Project	IEEE 802.16 Broadband Wireless Access Working Group < http://ieee802.org/16 >	
Title	Neighbor Discovery using Interference Free Coexistence Time Slot	
Date Submitted	2005-07-09	
Source(s)	Wu Xuyong Huawei Huawei Industrial Base, Bantian, Longgang, Shenzhen 518129 P.R.C	Voice: +86-755-28972214 Fax: +86-755-28972149 wuxuyong@huawei.com
Re:	80216h-05_014 : Call for Contributions IEEE 802.16's License-Exempt (LE) Task Group. 2005-06-09 Topic 3. Text for the IEEE P802.16h draft, according to the Table of Contents of the Working Document.	
Abstract	Proposes a protocol for neighbor discovery	
Purpose		
Notice	This document has been prepared to assist IEEE 802.16. It is offered as a basis for discussion and is not binding on the contributing individual(s) or organization(s). The material in this document is subject to change in form and content after further study. The contributor(s) reserve(s) the right to add, amend or withdraw material contained herein.

Neighbor Discovery using Interference Free Coexistence Time Slot

figure1. Concept of neighbor BSs in coexistence protocol

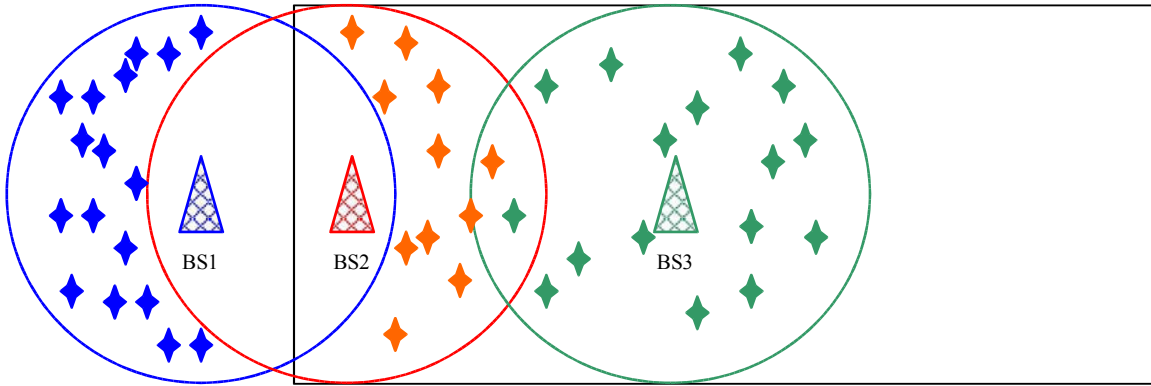
For example, as the figure 1 shown, BS1&BS2 have common coverage area , but no valid SSs exist in the common area, so BS1&BS2 are not neighbor, though BS1&BS2 could hear each other; BS2&BS3 have common radiation area, and there is valid SSs inside the common area, so BS2&BS3 form a neighborhood.

Neighbor BSs: *The base stations that have valid SSs in the common coverage area are called neighbor BSs, and shall form a neighborhood.*

There are 2 basic conditions to form a neighborhood:

- 1) *Common coverage area: base stations need to be close enough in geography;*
- 2) *Valid SSs exist in the common coverage area: When SS transfer data with one BS at a time, it shall consider other BSs as an interference source at the same time.*

Figure2. Timing of Coexistence Time Slot

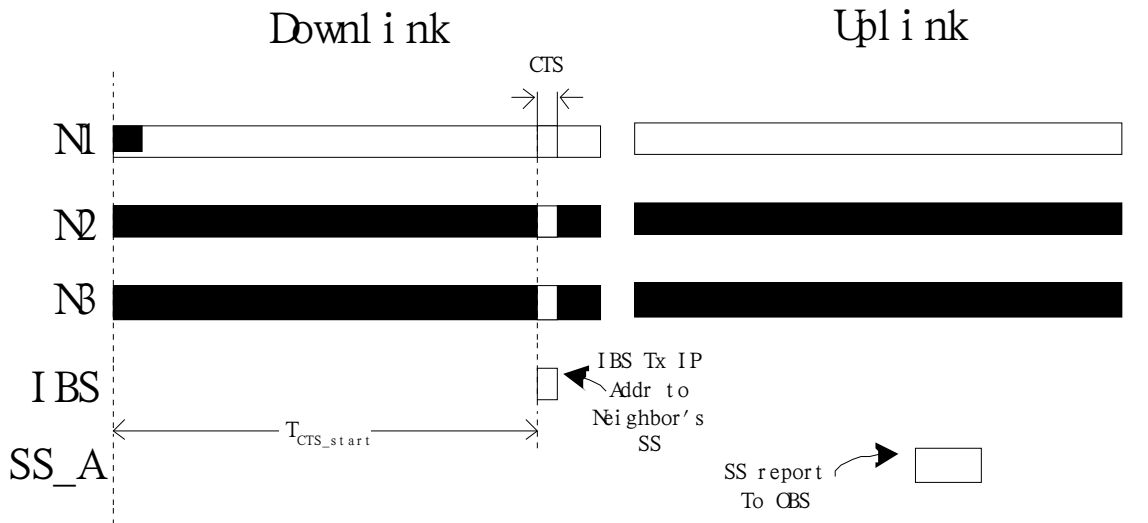
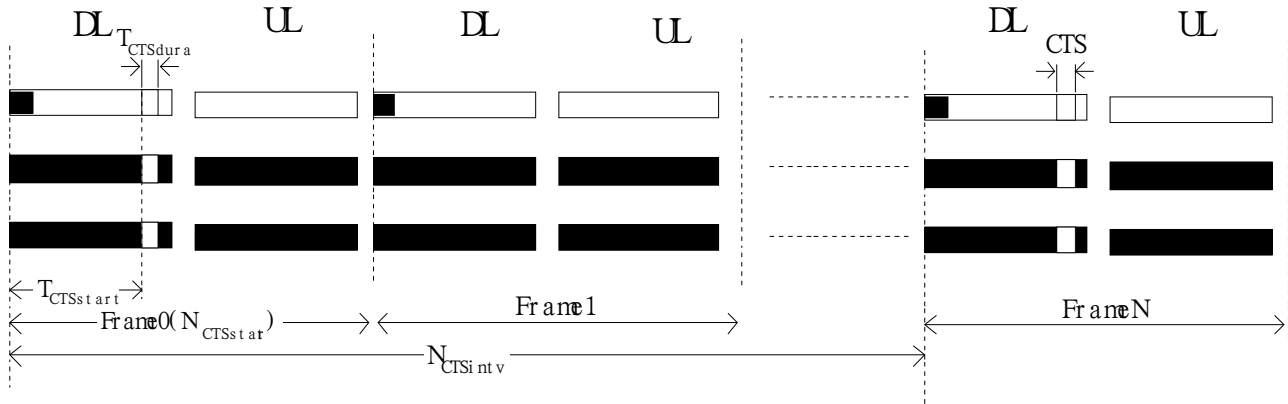
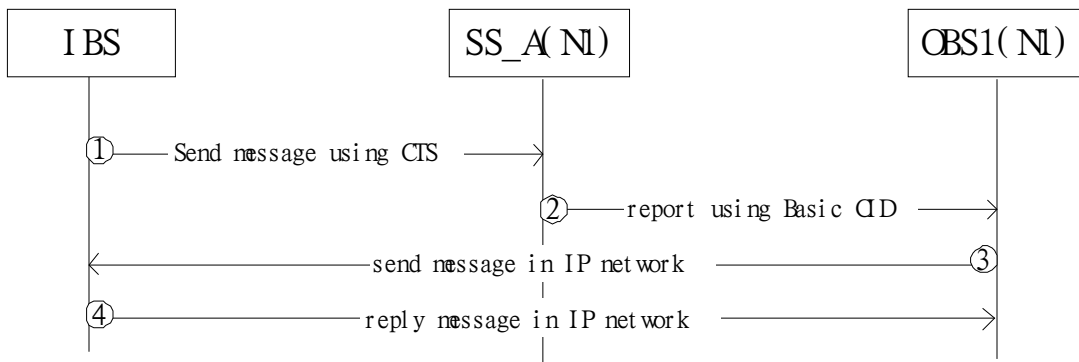
CTS (Coexistence Time Slot): a predefined time slot for the coexistence protocol signaling purpose, especially for the initializing BS to contact its neighbor operating BS through the SS in the common coverage area.

CTS must not be used for other purpose by all the BSs, so that it will be an interference free slot for the neighbor discovery purpose. Initializing BS (IBS) shall use this slot to broadcast its IP identifier, so that the neighbor operating BS (OBS) could find the new neighbor in IP network after the SS report the message. Then the IBS and OBS begin further negotiation for coexistence protocol. The broadcasting procedure is unidirectional, only from the IBS to the SSs in IBS's coverage, and the SSs shall

report all the useful information to their OBSs they registered to. If the message be forward correctly to the OBSs, the OBSs will then find the IBS in the IP network, and go further signaling using IP network. The CTS parameters need to be unified in particular region, and be well known by the BSs. So that each IBS could know the exact time to transmit the broadcasting message in its initialization. The parameters include:

- $T_{CTSstart}$: CTS starting time from the beginning of the frame (ms)
- $T_{CTSdurat}$: CTS duration time (ms)
- $N_{CTSstart}$: CTS starting frame number (frames)
- $N_{CTSintv}$: CTS interval frames (frames)

Figure 11 Initialization procedures – BS

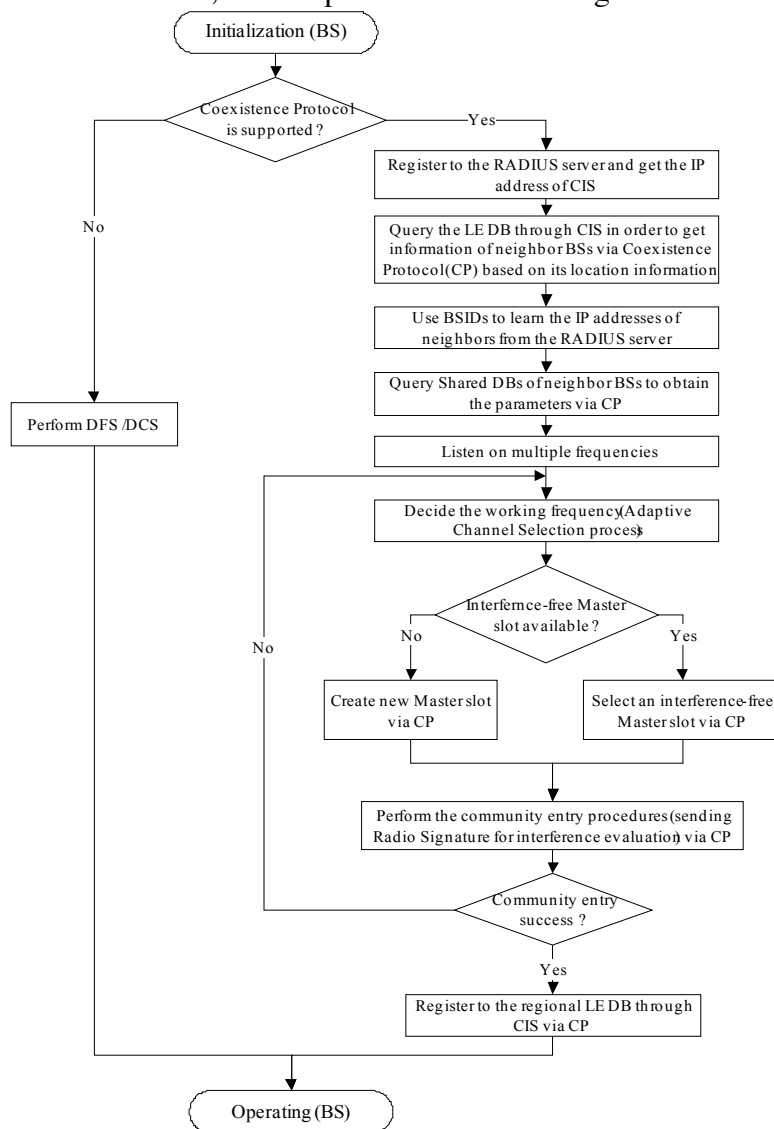
Proposed modification on the procedure:

Add a verdict process in the BS initializing procedure:

Check if the CIS server is valid, if CIS is Valid, use the original process to get the neighbor's IP address, otherwise, use the CTS to broadcast the IP identifier and contact request, and waiting for the reply from neighbors.

[change the figure 11 into the following chart]

•*The first phase of the Community Entry is to judge the validity of country/region data base. If the country/region database is valid, process uses the country/region (FCC) data base:*

- o Read the Regional/country (FCC) data base;*
- o Identify which Base Stations might create interference, based on the location information;*
- o Learn the IP identifier for those Base Stations;*

Otherwise:

- o New BS uses the interference free slot to broadcast the contact request*
- o The SS in the common coverage will forward the information to its operating base station.*
- o The operating neighbor BS send feedback information using IP network*
- o learn the IP identifier By the message from neighbor BS via IP network*
